RIVERSIDE COUNTY
PLANNING DEPARTMENT

RE: CONDITIONAL USE PERMIT NO. 230002 "Crescent Gardens Cemetery"

REQUEST: Conditional Use Permit No. 230002 is a proposal for the construction of a cemetery (25 acres of gravesite), mortuary, chapel, equipment shed, and caretaker manager residence.

Your proposal was scheduled for comments from the Development Advisory Committee (DAC) on **October 17, 2024.** Enclosed are the resulting comments from the Riverside County Planning Department and all other available comments and recommended Conditions of Approval.

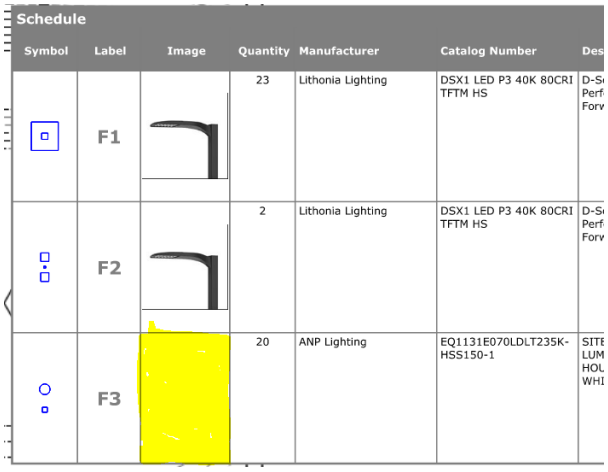
7. **Repeat Correction**: Provide a visual example of the F3 lighting proposed on-site so it can be verified that it's meeting lighting standards.
